Model: See Affected Systems

Product Bulletin # TDS-218

## Back-up Wrench Gripper Unintended Movement

Canrig top drives models C275 through C750.

Figure 2: Schematic for the BUW after removing the pressure reducing valve with check valve

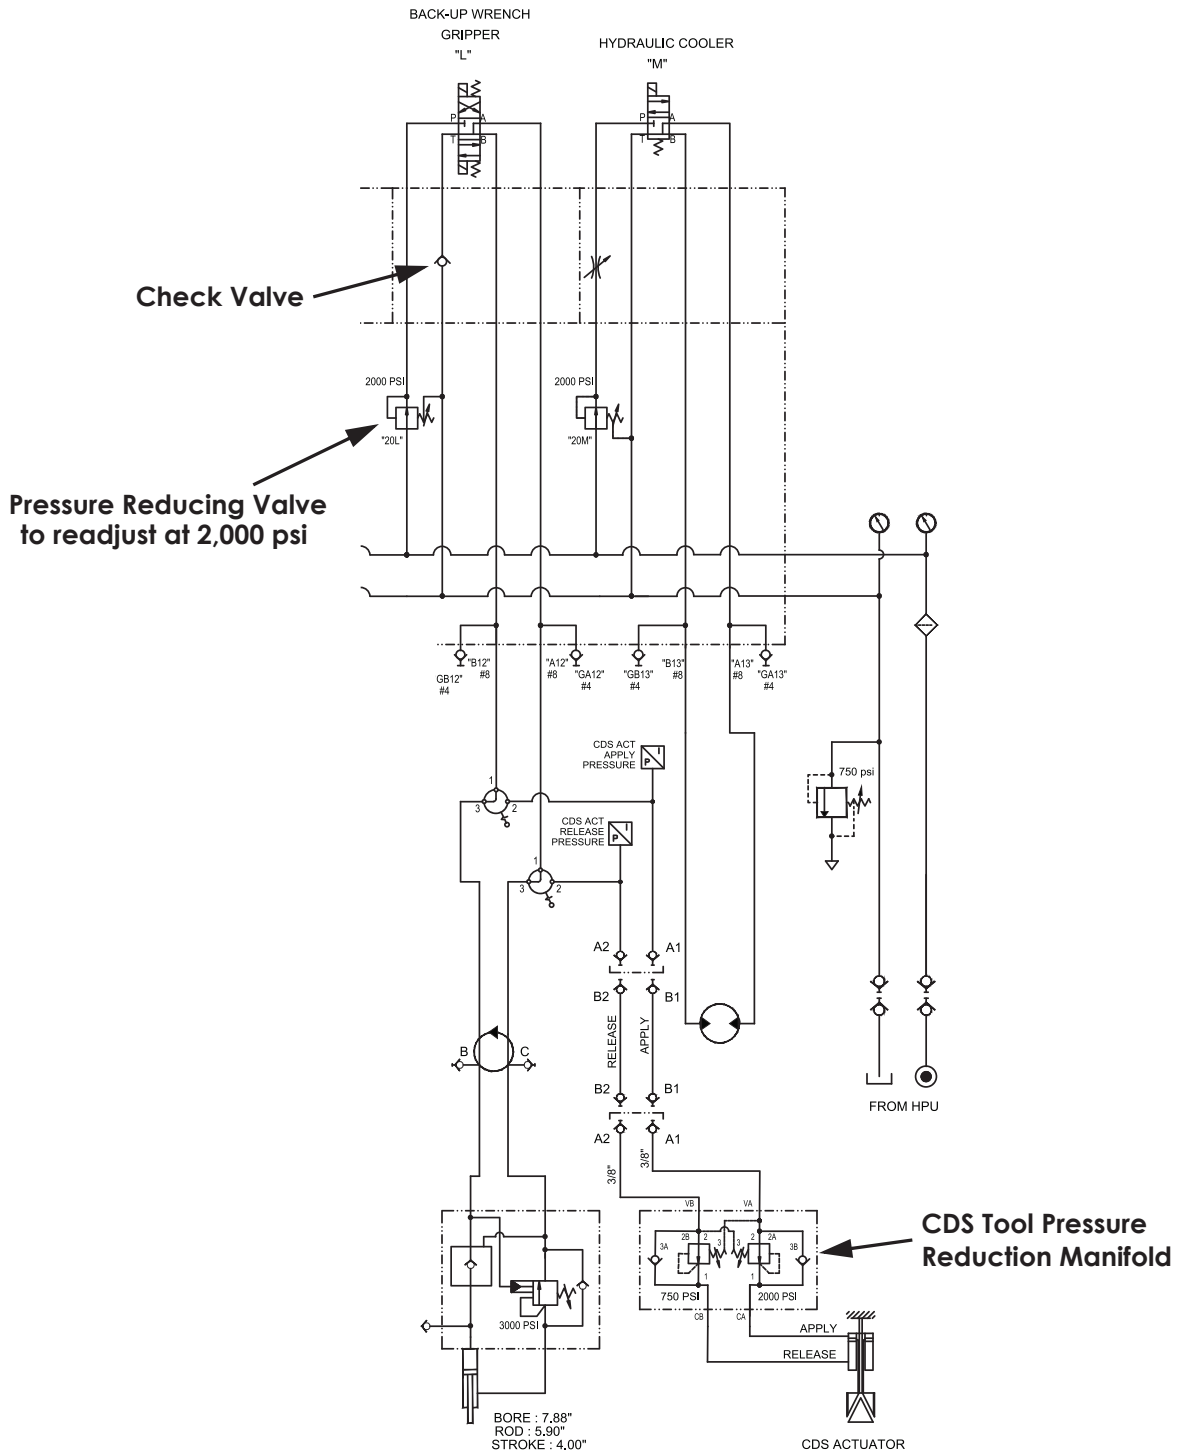
- To prevent this situation, remove the pressure reducing valve on station "L" (BUW gripper) of the top drive hydraulic manifold and install the check valve. Contact RIGLINE 24/7™ to order the kit (Canrig P/N: AY25154) and refer to section below "Check Valve Installation" on page 5. See Figure 2 on page 3 for schematic included with check valve stack attached to top drive hydraulic manifold.

Figure 3: Schematic for the BUW after removing the pressure reducing valve without check valve

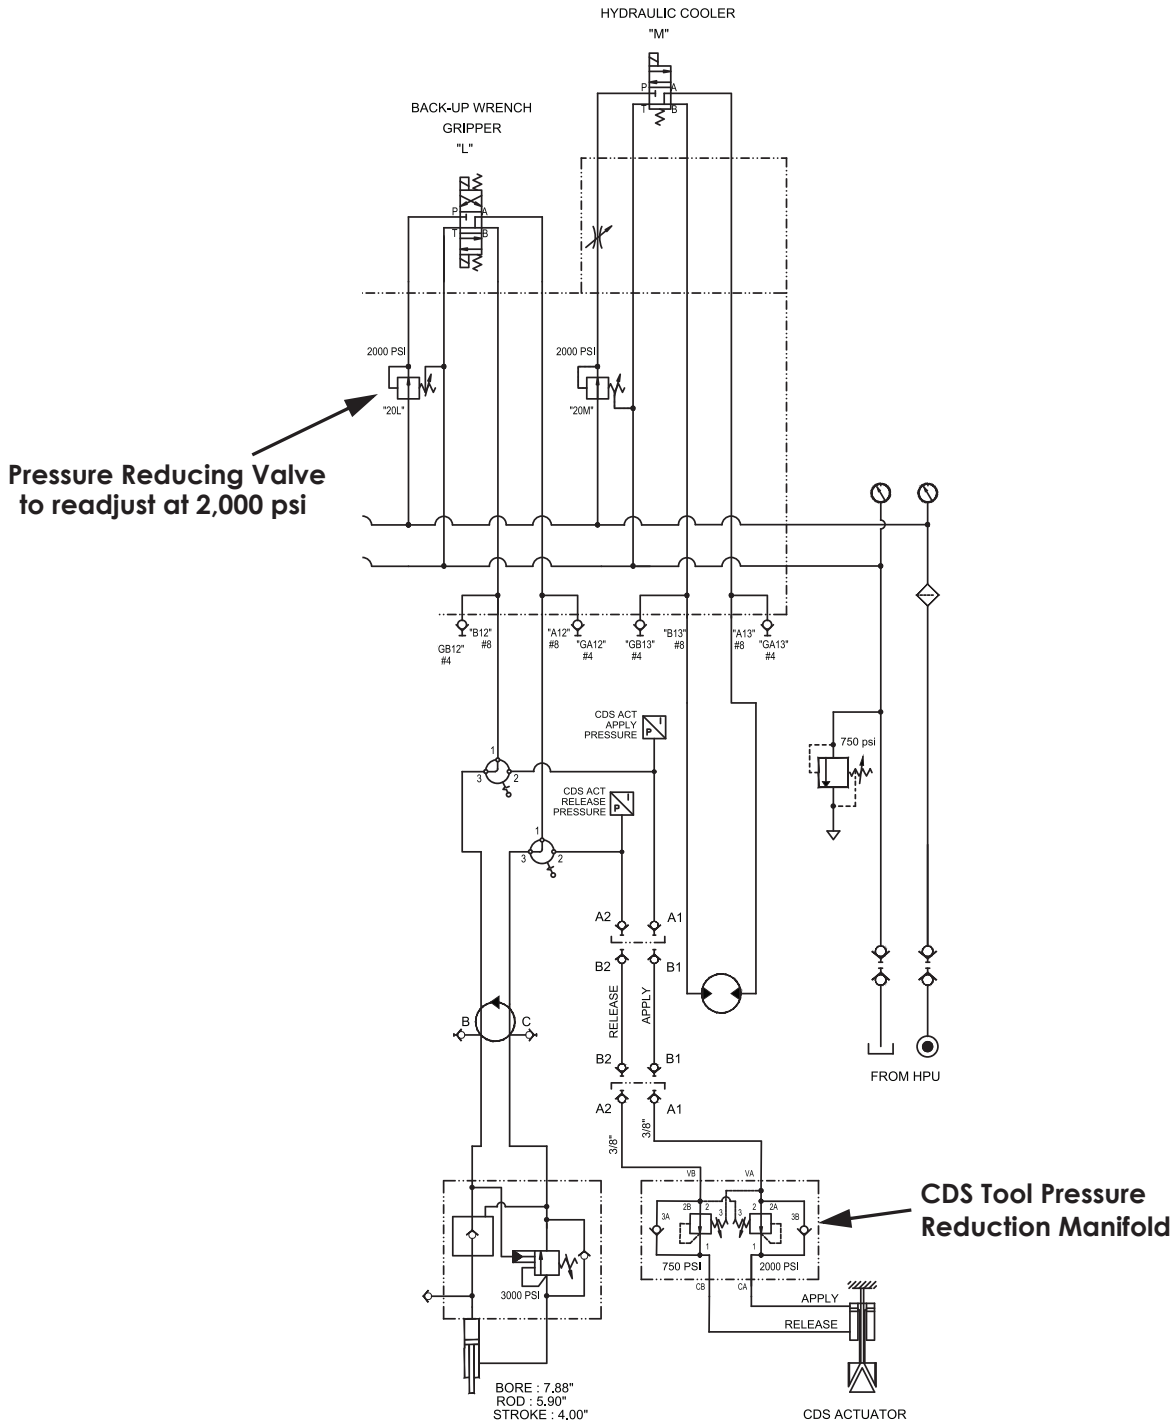
- If the kit (Canrig P/N: AY25154) is not being implemented per above, Canrig strongly recommends to remove the pressure reducing sandwich valve and install the BUW solenoid valve (DCV) back on manifold using socket head fasteners (Canrig P/N: SH-10-24-0200). See Figure 3 on page 4 for schematic.

- After removing the 750 psi pressure reducing sandwich valve, ensure the pressure reducing valve cartridge located at the 20L port on the hydraulic manifold is set to 2,000 psi.

Figure 4: Hydraulic manifold

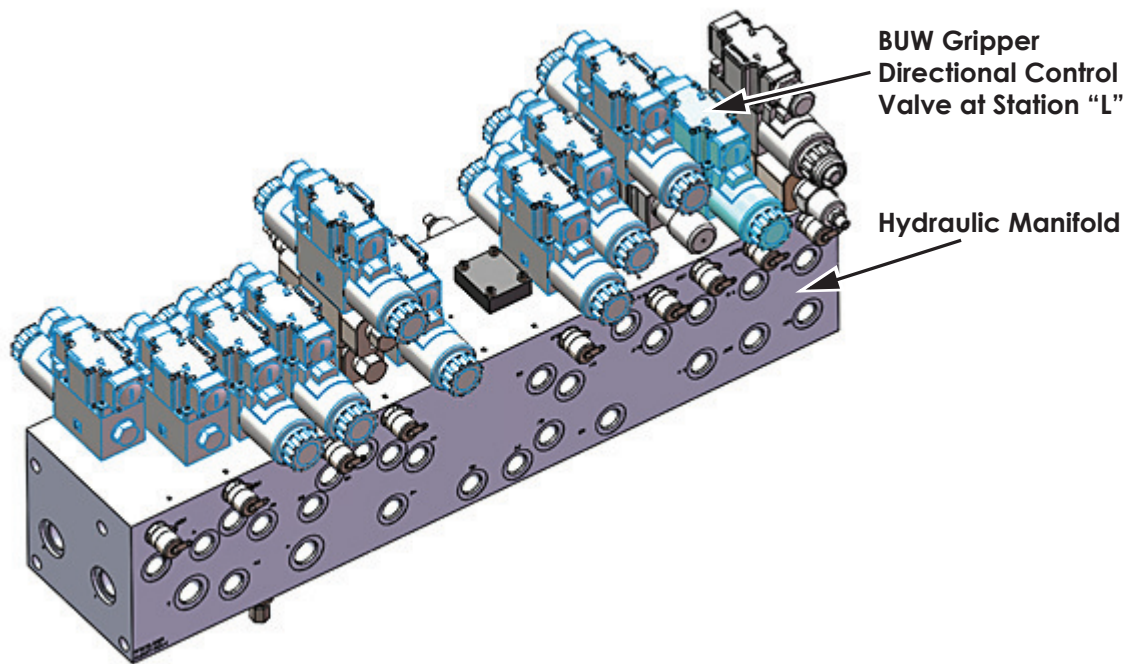
1. See Figure 4 to locate the BUW gripper valve bank (station L) on the top drive hydraulic manifold.

Figure 5: Pressure reducing valve

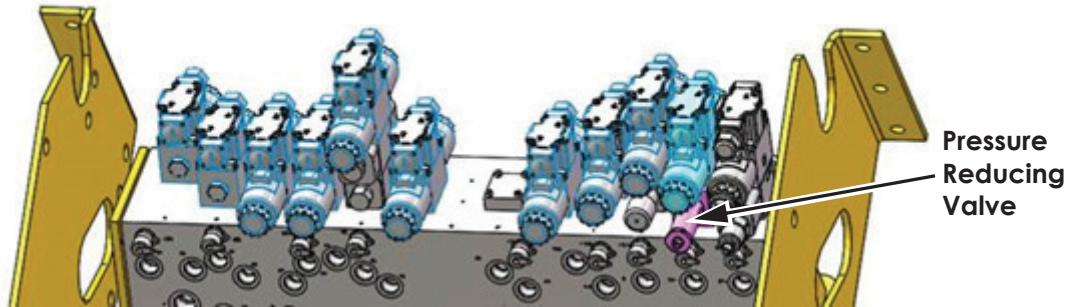
- Unscrew the fasteners to remove the pressure reducing valve (PRV) as shown in Figure 5. If the check valve is not available then install the BUW valve bank using the socket head fasteners (Carrig P/N: SH-10-24-0200).

Figure 6: Installing check valve

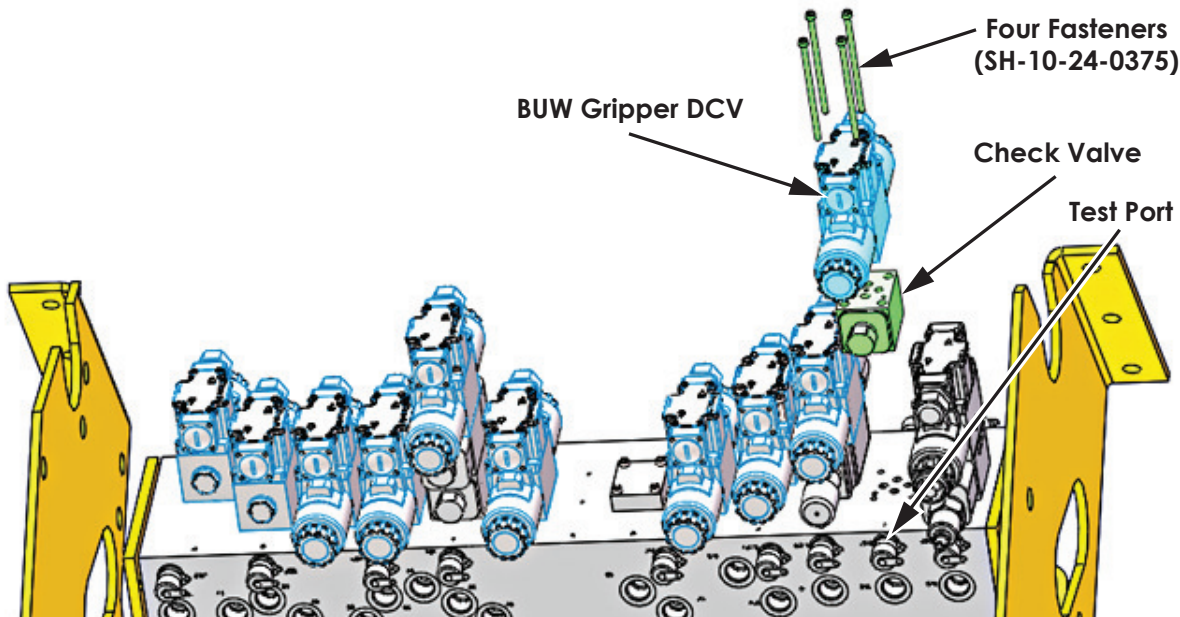
- Using the fasteners from the kit, install the check valve assembly (P/N: H07-1010-030) between the BUW gripper DCV and the hydraulic manifold as shown in Figure 6. Torque the fasteners to 6.5 ft-lbs using Loctite<sup>®</sup> 242.

**Warning!** Check valve knob must be oriented toward the hydraulic manifold test port as shown in Figure 5.
